Drinking Water Audit Report

County:	Kerry County Council	Date of Audit:	06/10/2014
Plant(s) visited:	Barraduff 1300PUB1015	Date of issue of Audit Report:	10/10/2014
		File Reference:	DW2009/103
		Auditors:	Mr Niall Dunne
Audit Criteria:	<ul style="list-style-type: none"> • The <i>European Union (Drinking Water) Regulations 2014 (S.I. 122 of 2014)</i>. • The <i>EPA Handbook on the Implementation of the Regulations for Water Services Authorities for Public Water Supplies (ISBN: 978-1-84095-349-7)</i> • The recommendations specified in the EPA Report on <i>The Provision and Quality of Drinking Water in Ireland</i>. • The recommendations in any previous audit reports.

Photograph 1: Flow in filter 3 was reading 0.00 m3/hr, Turbidity for filter 3 was reading 0.661NTU.

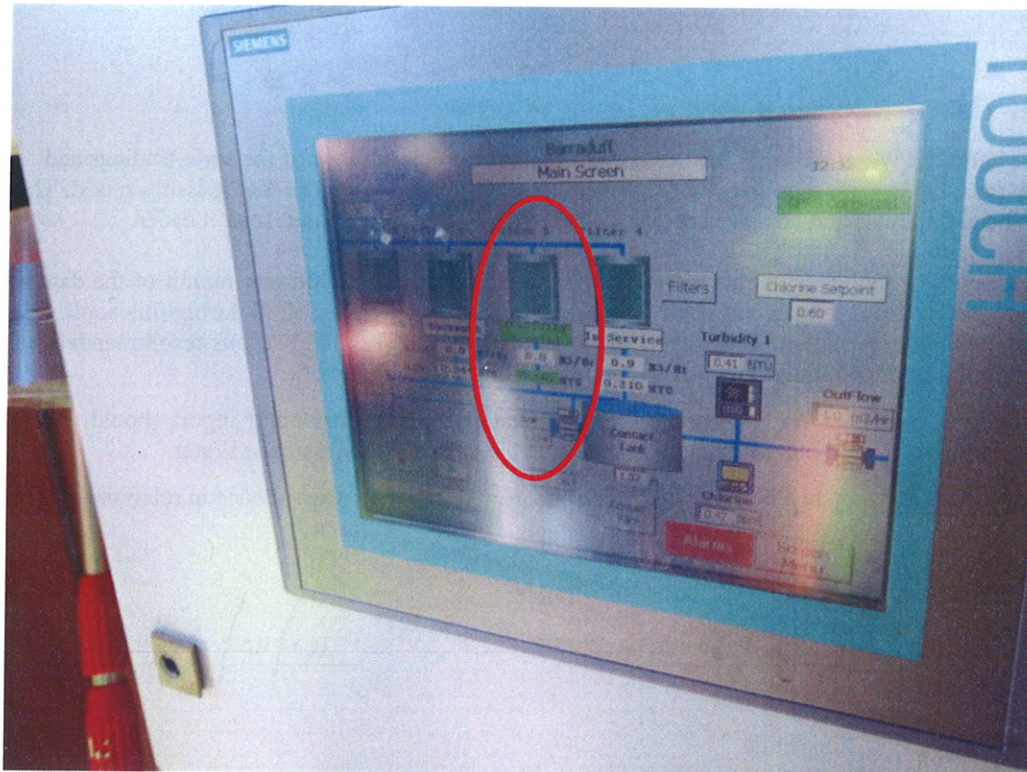
During the audit there appeared to be an issue with the displayed SCADA results for flow and turbidity for filter No 3. The Water Services Authority should ensure that the results displayed on SCADA are correct and that they mirror the results on the monitors.

4. The Water Services Authority should ensure that the readings for both flow and turbidity on the SCADA are properly displayed and correct.
5. Water Services Authority should investigate the difference in flow across filters, and should investigate turbidity increases as flow increase through the filters.
